**DEFENSE NUCLEAR FACILITIES
SAFETY BOARD**

Staff Issue Report

December 10, 2014

SUBJECT: Review of the System Back Out Plan and Ventilation System for the Plutonium Finishing Plant Project

Figure 1. PFP HEPA Filter Design

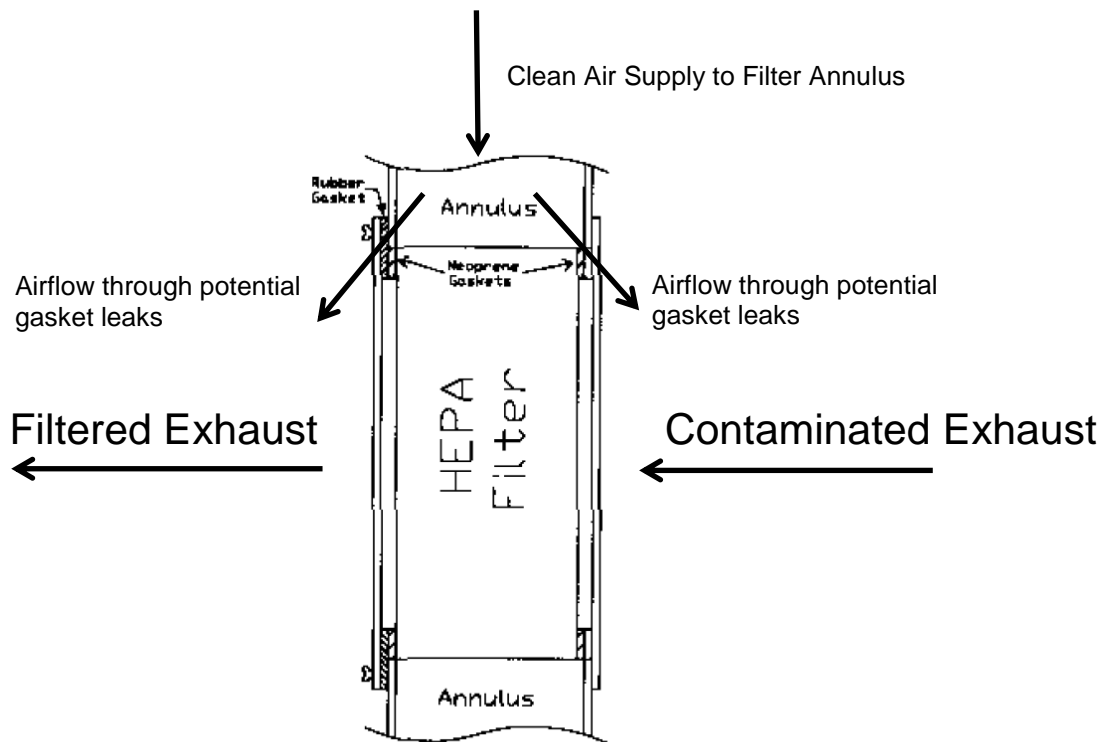
The PFP HEPA filter plenum includes a unique capability to mitigate the effects of potential leakage around the HEPA gaskets that seal the filter to the plenum (see Figure 1). The design includes a gasket on the up and downstream faces of each filter, creating an annular space around the filter case. For ~45 years, a separate air supply system provided the annular space with clean, pressurized air to ensure that any gasket leaks resulted in the flow of clean air into the filter plenum rather than the flow of contaminated exhaust air around the filter gaskets. In the mid-1990s, PFP personnel terminated operation of the system's supply fan due to high vibration. The supply system continued to operate passively, relying on the negative pressure in the filter plenum to pull clean air from the supply system through any gasket leaks. Over time, the HEPA gasket seals deteriorated and flow through the supply system increased. Recent repairs and changes in damper position have reduced the flow through the system to a negligible level.

The PFP TSR requires an annual aerosol leak test of the HEPA filters to ensure that leakage around or through the filters remains within the limits prescribed by the safety basis. The review team questioned the adequacy of the leak test to detect leakage around the filters given their unique design. Specifically, because the supply system communicating with the annular space around the filters provides clean air to any leak sites, the aerosol leak test would not be capable of detecting a potential leak path around the filters (i.e., the influx of clean air

would preclude test aerosol from leaking past the gaskets). The only indication available to detect HEPA gasket degradation, and thus the potential for bypass leakage, is a differential pressure gauge on the supply system that provides a crude estimate of the airflow leaking through the gaskets into the filter plenum. The TSR, however, does not establish requirements to monitor this flow. Consequently, the review team concluded that the TSR does not establish an adequate surveillance for confirming HEPA filter operability.

The review team expressed further concern that the system configuration could lead to an unanalyzed bypass leakage condition during accidents that result in high filter loading such as a major fire. As HEPA filters load with particulate during an accident, the ventilation control system maintains the pressure upstream of the HEPA filters constant while the pressure downstream becomes more negative. The increasing pressure drop across the HEPA filters could facilitate a bypass leakage pathway around the filters if the gaskets are not leak tight and the leakage through the downstream gasket is sufficient to draw the annular space negative with respect to the plenum upstream of the HEPA filters.

The review team acknowledges that significant dilution would be expected for any bypass leakage due to the elevated release from PFP's stack. However, the review team concluded that the bypass scenario could challenge the efficiency credited in the DSA for the safety-significant HEPA filters. CHPRC and DOE-RL personnel did not disagree with this concern. Before committing to address it, they are reviewing previous technical analyses that they believe evaluated potential bypass leakage pathways. They committed to providing the staff with the results of their investigation upon completion.
